2019/4241/P & 2019/4517/L - 30 Percy Street, W1T 2DB

Delegated Report (Members Briefing)		Analysis sheet N/A	Expiry Date: 11/10/2019	Consultation Expiry Date: 27/10/2019	
Officer			Application Number(s)		
Patrick Marfleet			2019/4241/P & 2019/4517/L		
Application Address			Drawing Numbers		
30 Percy Street London W1T 2DB			Please refer to draft decision notice		
PO 3/4	Area Team Signature	C&UD	Authorised Officer Signature		
Proposal(s)					
Internal and external alterations including replacement rear extension at ground floor and basement level with roof terrace above, change of use of existing flat (Class C3) at second and third floor level to office space (Class B1a) and use of basement level as social enterprise space.					
Recommendation(s):		Grant conditional planning permission and listed building consent subject to s106 legal agreement			
Application Type:		Full Planning and Listed Building Consent Application			
Conditions or Reasons for Refusal:		Refer to Draft Decision Notice

Proposal: Internal and external alterations including replacement rear extension at ground floor and basement level with roof terrace above, change of use of 3 bed flat (Class C3) at second and thi

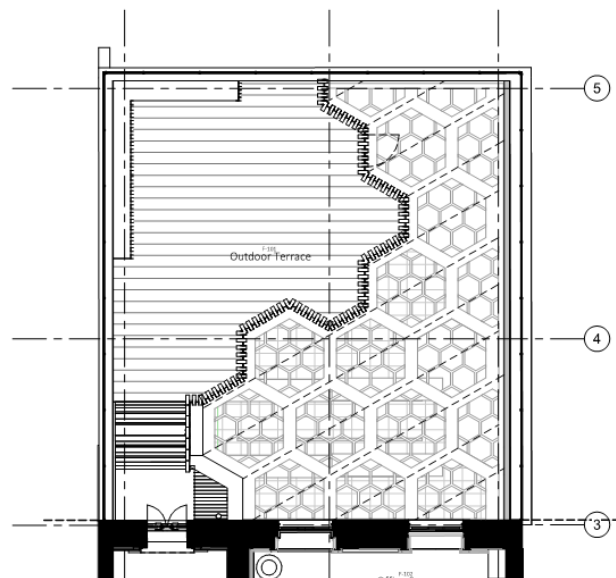
2.4.3 As mentioned above, the overall height of the proposed extension would be approximately 1 metre lower than the existing extension at the site however, the proposed works would also increase the height of the shared boundary wall between nos.30 and 29 by approximately 900mm. Notwithstanding this, it is important to note the height of the existing boundary wall between the aforementioned properties, which is currently 6.7 metres. Therefore, the proposed alterations to the existing boundary wall would

lead to an increased height of approximately 7.6 metres along the shared boundary, which is not considered significant enough to cause harm to the rear garden area and nearest windows of the adjoining property at No.29 in terms of loss of light or increased overshadowing. This impact would be the same for the adjoining property at No.31 which is in commercial use. The proposals do also include the installation of a privacy screen around the perimeter of the proposed terrace at first floor level. However, the height of the screen (approx. 750mm), coupled with its set in from the edge of the boundary wall, is not considered to cause harm to neighbouring amenity in terms of loss of light or outlook.
